Re: North Valley Trails Project Comments

March 30, 2022

Strand Bonus to 409 Trail for the following reasons:

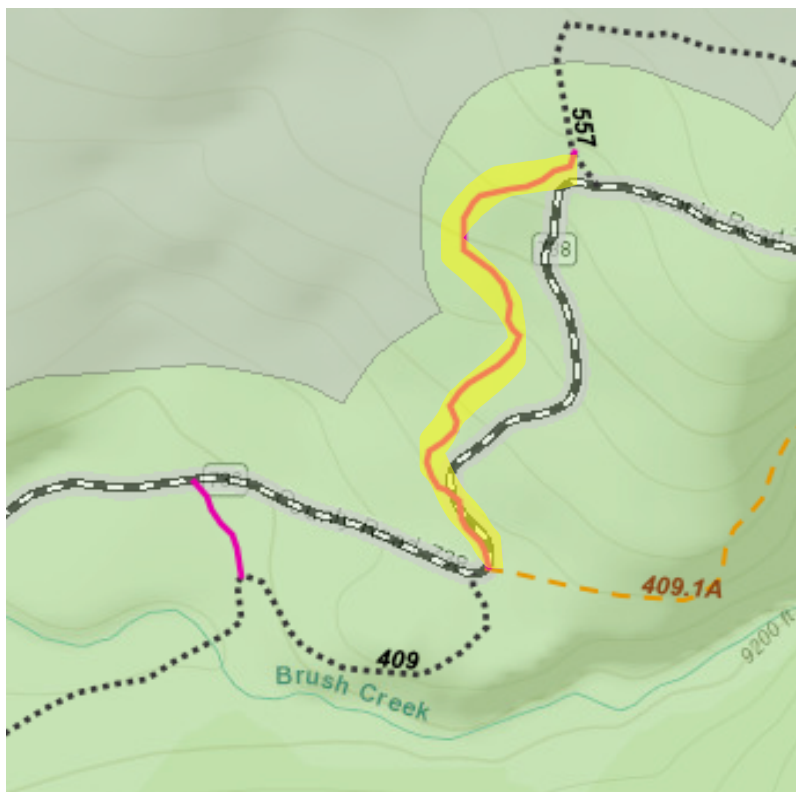
Opposed to (areas highlighted in yellow)

- 1: Trail bypasses the essential General Information Kiosk.
- 2: There already exists a close and very nice, user friendly route for multiple use. The proposed trail would be another unnecessary fragmentation of the land and would greatly disrupt historic cattle safe harbors.
- 3: The proposed trail as illustrated creates yet another gate in very close proximity to a new user-friendly swinging gate accompanied with a walkover. If this proposed trail is allowed, we request that the trail go to the existing walkover and gate (highlighted in green).

4: If the proposed new trail is not allowed to move forward, and all users continue using the existing road, there is a small section of the existing road that is rocky for bicycles. A small section of trail, paralleling but close to the road (shown in blue), could be developed to mitigate the rough area.

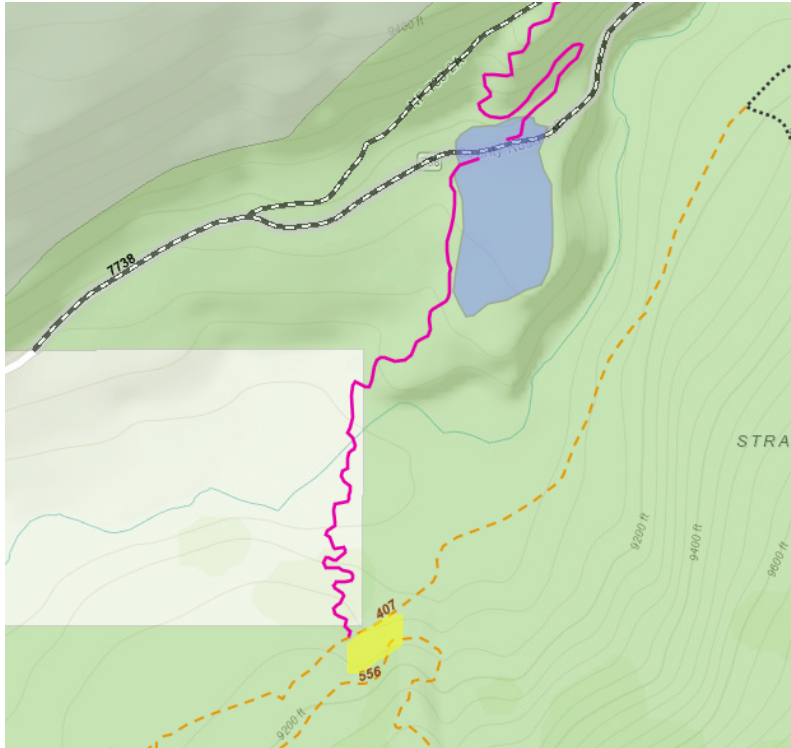
1: Opposed to (see areas highlighted in yellow) **Teocalli Extension** because the proposed trail is equally as steep as the parallel road. There is potential for more major erosion and a source for more atmospheric dust.

2: Safety Issue: The road paralleling the proposed trail is already an attractant for speed jumping. The proposed trail likely will be an even greater enticement for high-speed participants, a mindset that is always dangerous and does not balance well with the other users.
